Project Number: SP2018-022
Project Name: Rustic Warehouse
Project Type: SITE PLAN
Applicant Name: [APPLICANT]
Owner Name: T-ROCK, LP
Project Description:

RE: SITE PLAN (SP2018-022), Rustic Warehouse

| Type of Review / Notes | Contact | Sent | Due | Received | Elapsed Status | Remarks |
|--|---------|------|-----|----------|----------------|--|
| SP2018-022 Site Plan for Rustic Warehouse: Please address the following comments (M= Mandatory Comments; I = Informational Comments) | | | | | | |

RUSTIC WAREHOUSE
FRONT ELEVATION & FLOOR PLAN

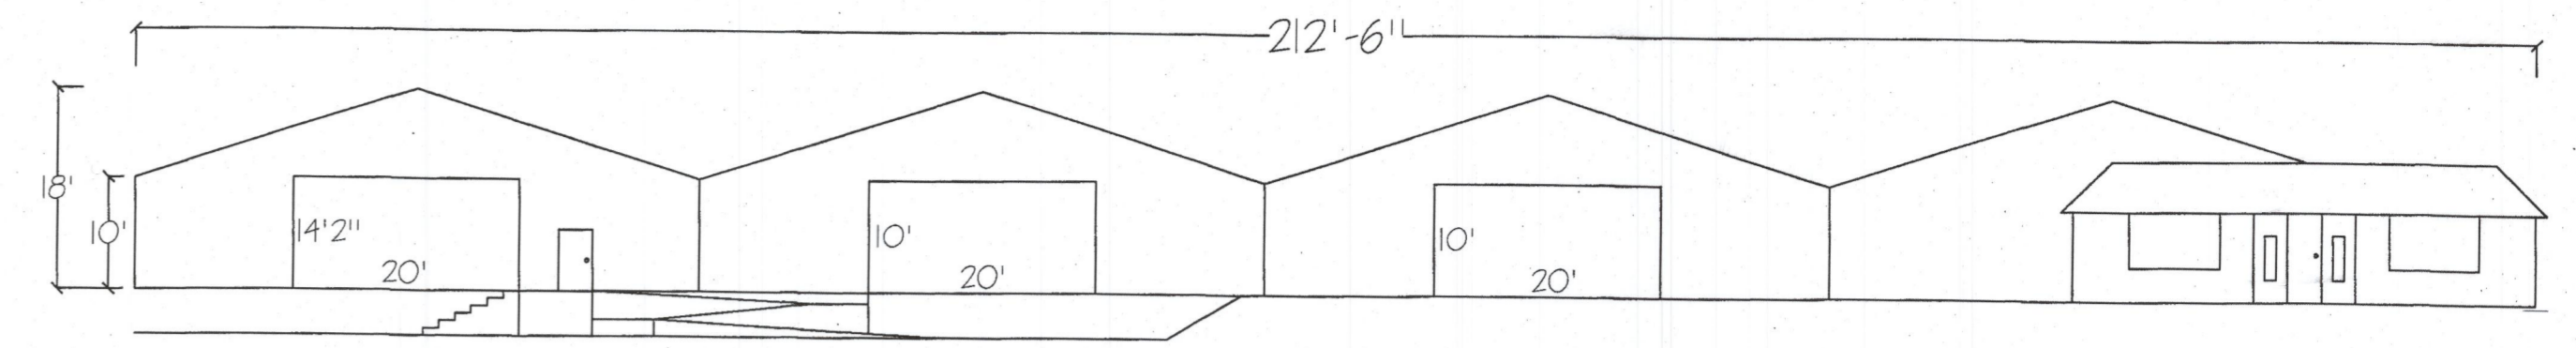
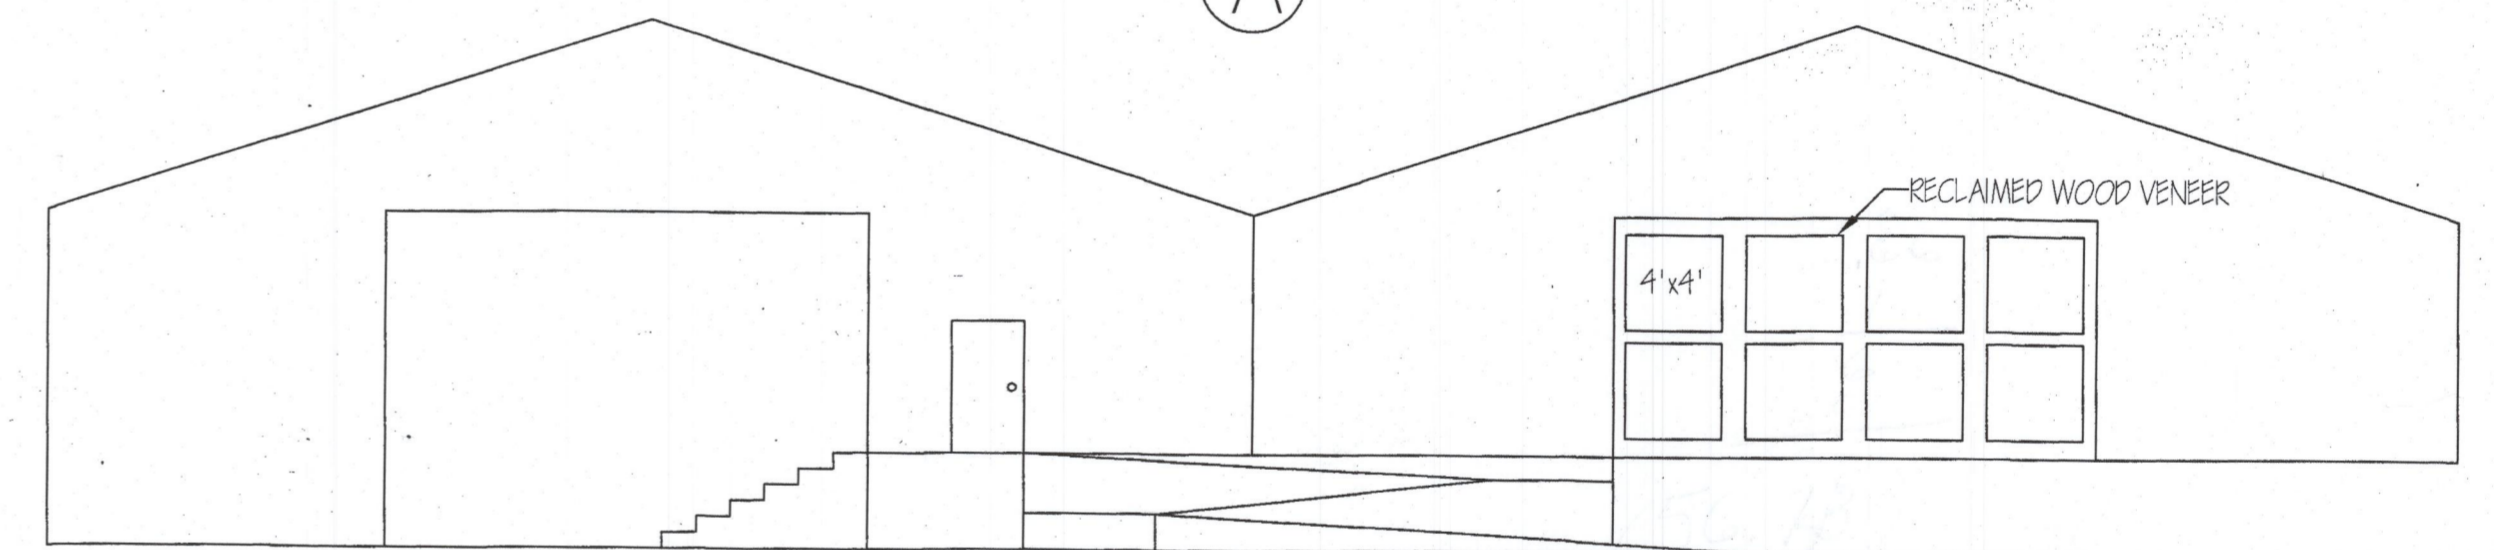
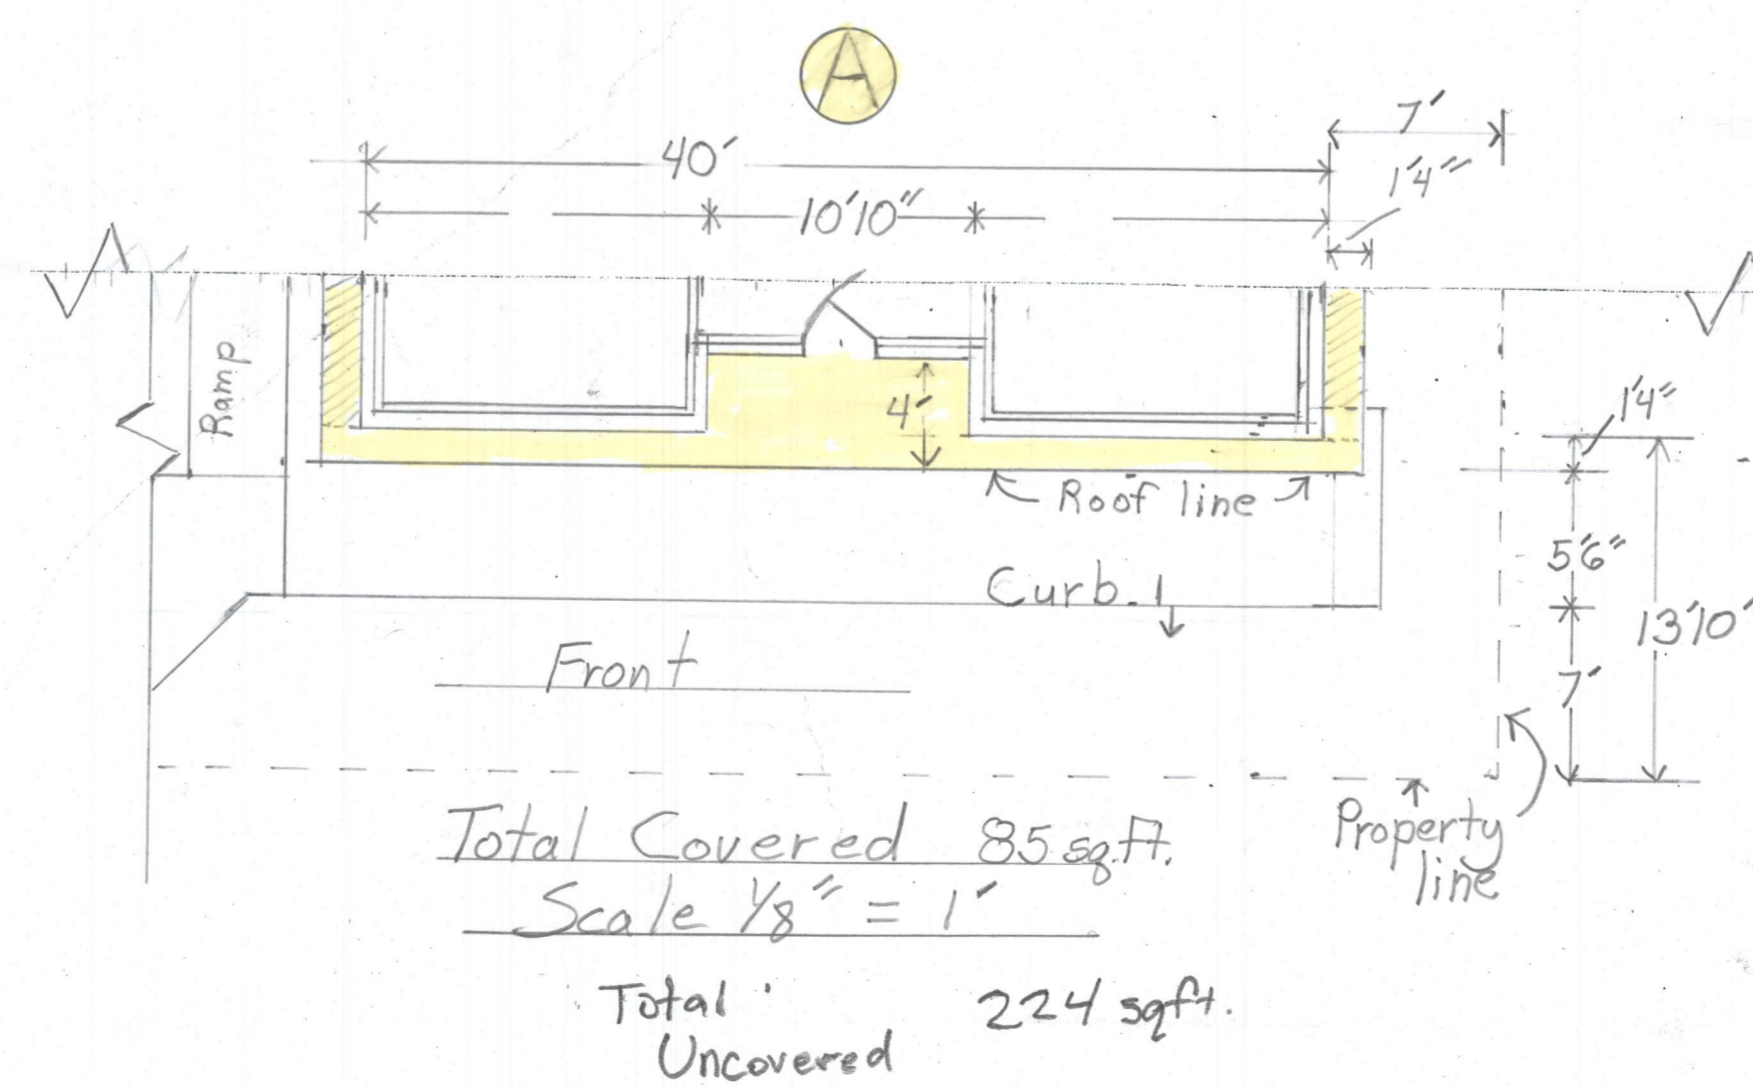
| Type of Review / Notes | Contact | Sent | Due | Received | Elapsed Status | Remarks |
|--|---------|------|-----|----------|----------------|--|
| M.4 | | | | | | Outside storage requires a 5-foot passable sidewalk. Please show on site plan. |
| M.5 | | | | | | Outdoor sales and displays are permitted only in areas designated on the site plan filed with the city. Outdoor sales and display may not exceed five percent of the adjacent building floor area. (Building area is defined as the entirely enclosed air conditioned portion of the primary building.) |
| M.6 | | | | | | Outdoor sales and display may occupy up to 30 percent of a covered sidewalk that is located within 20 feet of the building. Such display shall not impede pedestrian use of the sidewalk and at least a six-foot passable distance shall be maintained. |
| M.7 | | | | | | Any outside sales and display not located on a covered sidewalk must be screened from view of adjacent roadways, public areas and adjacent properties. Such screening must: a. Be a minimum of eight feet high or one foot taller than the materials being displayed, whichever is greater. b. Include minimum of 20 percent solid screening matching the material of the primary building. The remainder may be solid evergreen planting, or wrought iron, dark vinyl coated chain link or similar materials. |
| M.8 | | | | | | Any outside sales and display not located on a covered sidewalk must be located immediately adjacent to or connected to the primary structure. No outdoor sales and display may be located in any portion of a parking lot. |
